REGIONAL REVIEW NOTIFICATION

Name of Proposal: The Heights at Clairmont (Fairfield at Clairmont)

Review Type: Development of Regional Impact

Preliminary Report:	June 4, 2007	DEVELOPMENT OF REGIONAL IMPACT REVIEW REPORT	Project:	The Heights at Clairmont # 1387
Final Report Due:	July 4, 2007		Comments Due By:	June 18, 2007

PROPOSED GRITA DRI PLAN
CLAIRMONT LODGE
 Land Lots 196 & 197 - 18th District
 DEKALB COUNTY, GEORGIA

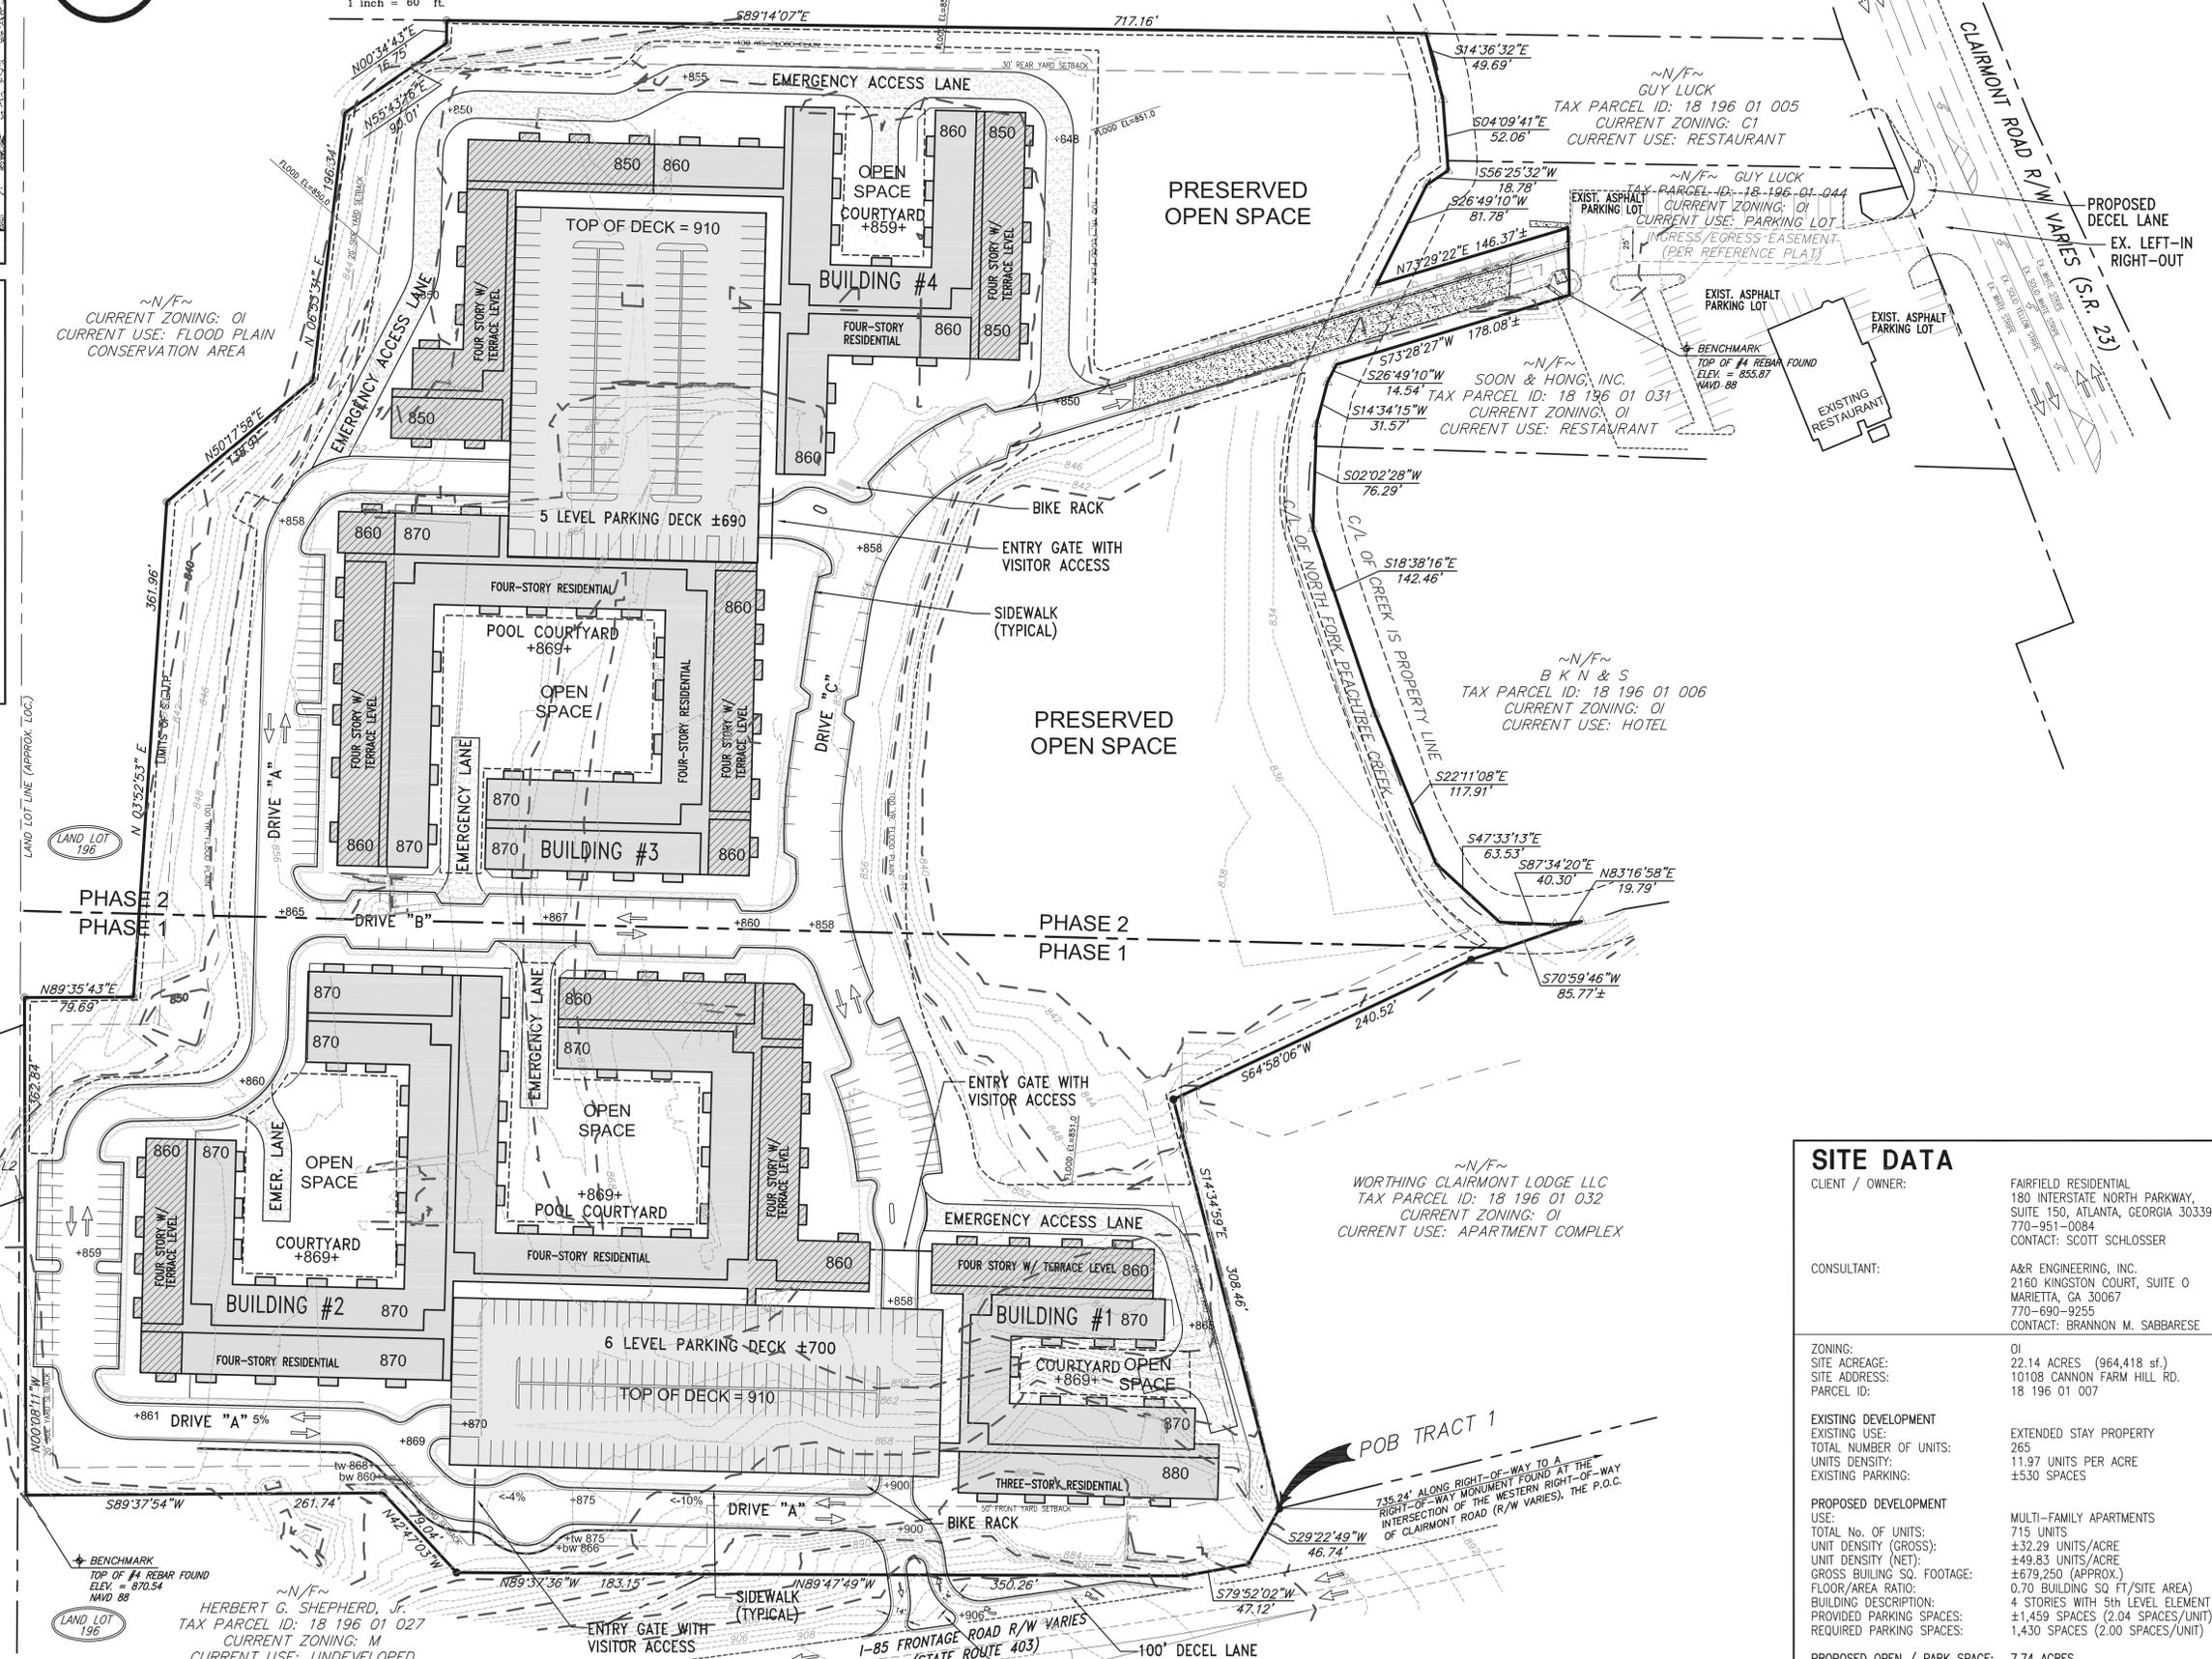
The proposed development should provide adequate pedestrian access to the transit stops along Clairmont Road. Other pedestrian and bicycle access should be considered along North Fork Peachtree Creek. According to DeKalb County’s Future Development Plan, the area around the creek is designated as conservation and greenspace. The overall intent is to protect open spaces that follow a linear features for recreational and conservation purposes. Policies within the plan include expanding and connecting trail systems throughout the County. It is encouraged that the developer and DeKalb County work together to ensure that future trail connections can be made through the side and provide direct access to individuals residing within the development.

It is important that stub outs to adjacent development are provided for future street connections as it is likely that other properties within the immediate area will redevelopment.

The North Fork of Peachtree Creek runs along eastern side of the project property. While the 75-foot DeKalb County stream buffer is not shown, all new development on the property, except for any improvements to or replacement of the existing bridge over the stream, is more than 160 feet from the stream. Any unmapped streams that may be on the property will also be subject to the DeKalb County stream buffer ordinance. All state waters on the property will be subject to the 25-foot Erosion and Sedimentation Act buffers, which are administered by the Environmental Protection Division of Georgia DNR. Any work within these buffers will require a variance from Georgia EPD.
